RAPID CITY REGIONAL AIRPORT**ADDENDUM NO. 3**

**Request for Proposals – Integrated Terminal Technology Package
Comprising CUPPS, CUSS, MUFIDS (Including GIDS and BIDS), and Digital Backwall Video Signage
Rapid City Regional Airport**

Date of Issuance: August 12, 2026

**RAPID CITY REGIONAL AIRPORT
RENOVATION AND EXPANSION PROJECT
PROJECT 1 PHASE 3**
Rapid City, South Dakota

SHEET NO.:
A-101

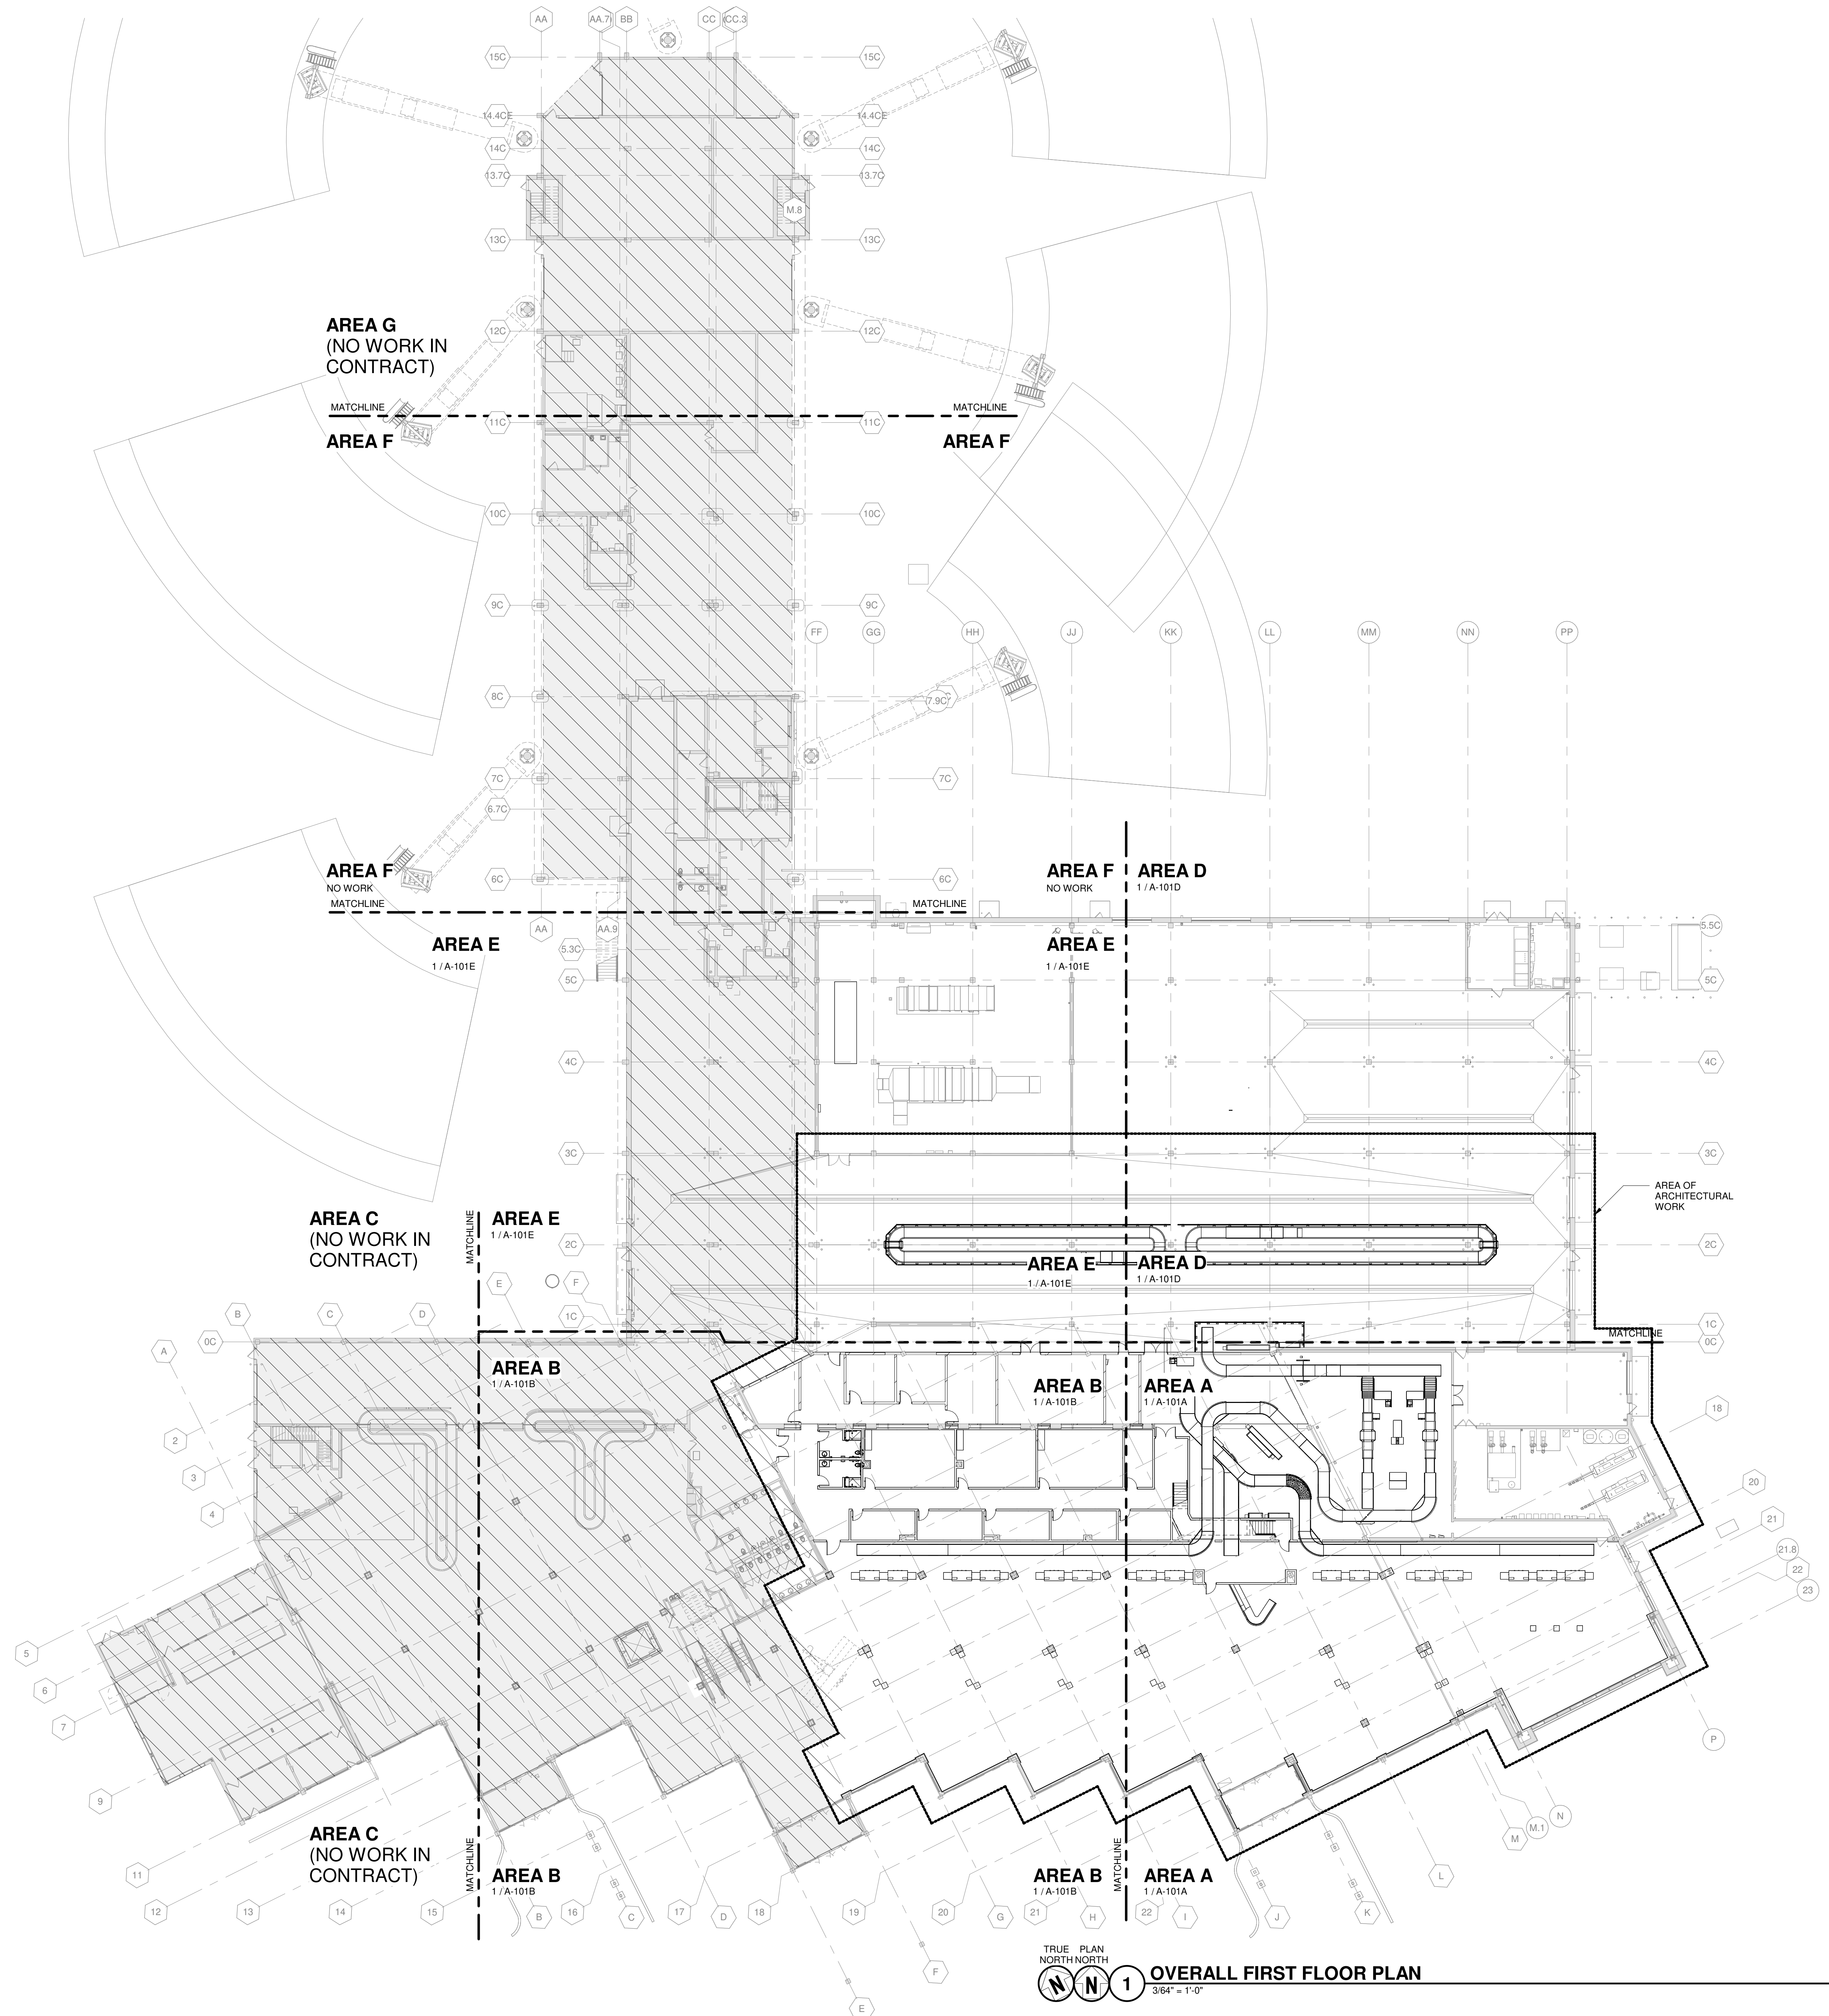
Section 3.1 of the Existing System Technical Reference Packet asks Proposers to identify required rack units, power, cooling, and cabling relative to the Airport's IT closets, and Section 5.0 references device siting throughout the ticketing, baggage, and gate areas. To support that requirement, the Airport is issuing the following Phase 3 first floor plans as Attachments 2 through 4 to this Addendum:

These sheets show the ticketing lobby, baggage screening and claim areas, and the Technology Room (T148) referenced in Section 3.1 of the Existing System Technical Reference Packet, for Proposers' general spatial reference in sizing cabling runs, bandwidth, and device placement.

Two limitations apply. First, this issuance covers only the ticketing, baggage, and back-of-house areas within the matchline boundaries of Attachments 3 and 4; the areas marked "No Work in Contract" on Attachment 2, and the gate concourse and related expansion areas beyond the matchlines shown, are not included. A Proposer requiring gate-area layout for GIDS siting should submit a written request under Section 2.3. Second, architectural notes on these sheets addressing wall assemblies, demolition, and construction sequencing reflect general contractor scope under the responsibility matrix in Section 3.4 of the Existing System Technical Reference Packet and are not applicable to the Contractor's scope of work under this RFP.
